Work Order ID 120865

Item ID: D407-667-105 Accept *N900040100* Setup Start *NS1*
 Revision ID: Stop *NS2*
 Item Name: Fwd Crosstube
 Start Date: 6/12/14 Start Qty: 1.00 *1* Cust Item ID:
 Required Date: 6/12/14 Req'd Qty: 1.00 *1* Customer:
 Reference:

DRAWING NO. D407-667-145	TITLE CROSSTUBE ASS'Y (407 HIGH FWD)	REV. C	DART AEROSPACE LTD ENGINEERING ORDER		D.E.O. NO. D407-667-145-C-1	SHEET NO. SHEET 1 OF 1	SCALE NTS
DRAWN <i>qp</i>	CHECKED <i>ASS</i>	MFG. APPR. <i>AB</i>	APPROVED <i>WD</i>		DE APPR. <i>##</i>		
DATE 11.07.15	DATE 11.07.22	DATE 11.07.22	DATE 11/07/22		DATE 11.07.21

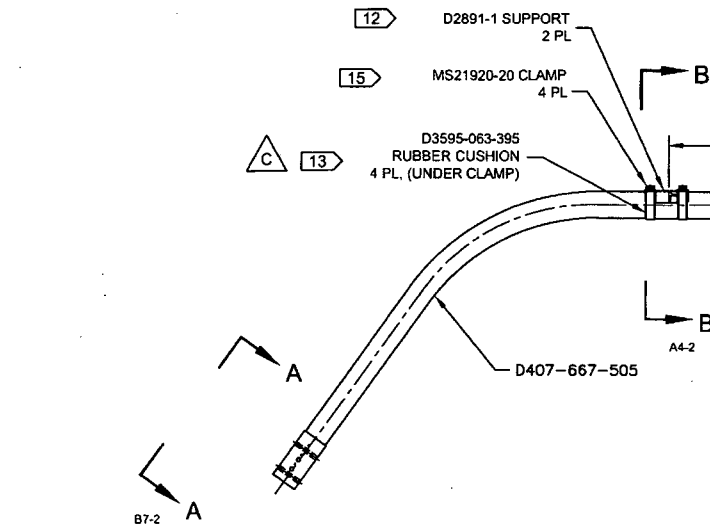
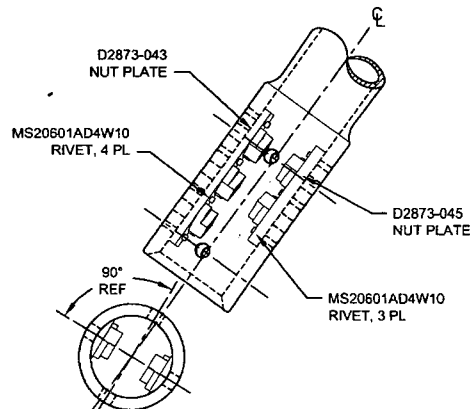
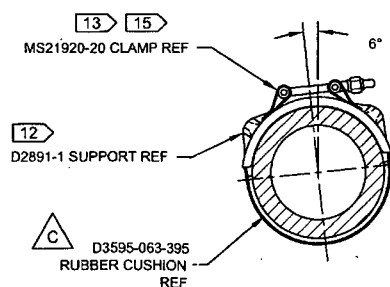
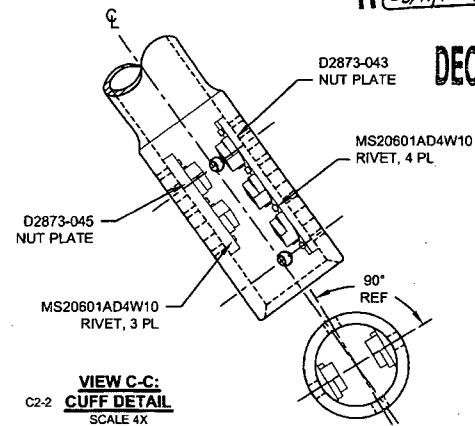
ECN #11.615
11.07.28
UNDER REVIEW
07/11/06

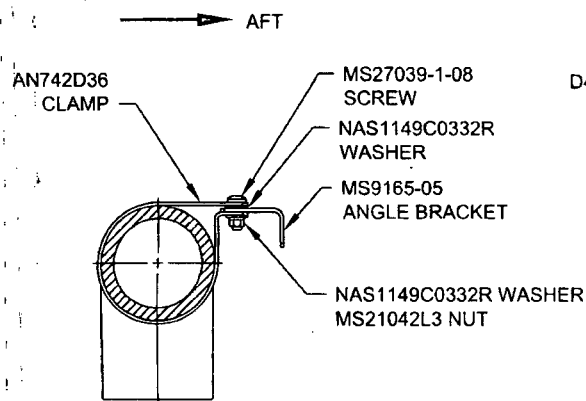
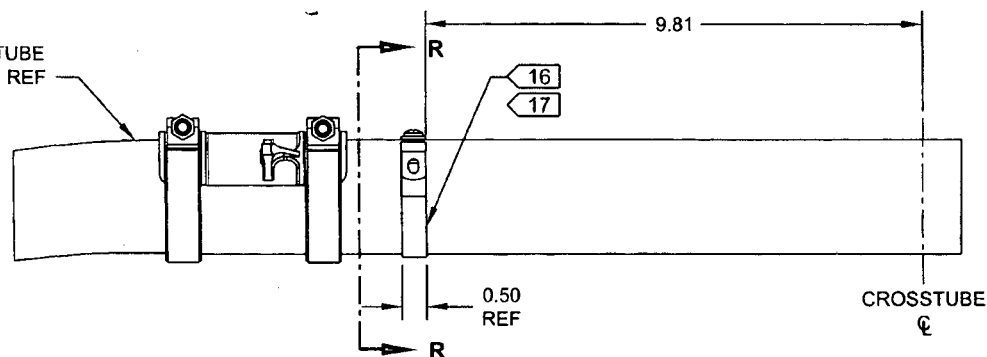
ADD ELECTRICAL GROUNDING STRAP

ITEM	QTY -145	PART NUMBER	DESCRIPTION
1	X	D407-667-145	CROSSTUBE ASSEMBLY (407 HIGH FWD)
10	2	AN742D36	CLAMP
11	2	MS9165-05	ANGLE BRACKET
12	2	MS21042L3	NUT (OR MS21042-3)
13	2	MS27039-1-08	SCREW
14	4	NAS1149C0332R	WASHER (OR AN960C10L)

DETAIL P
BONDING STRAP INSTALLATION 2 PL
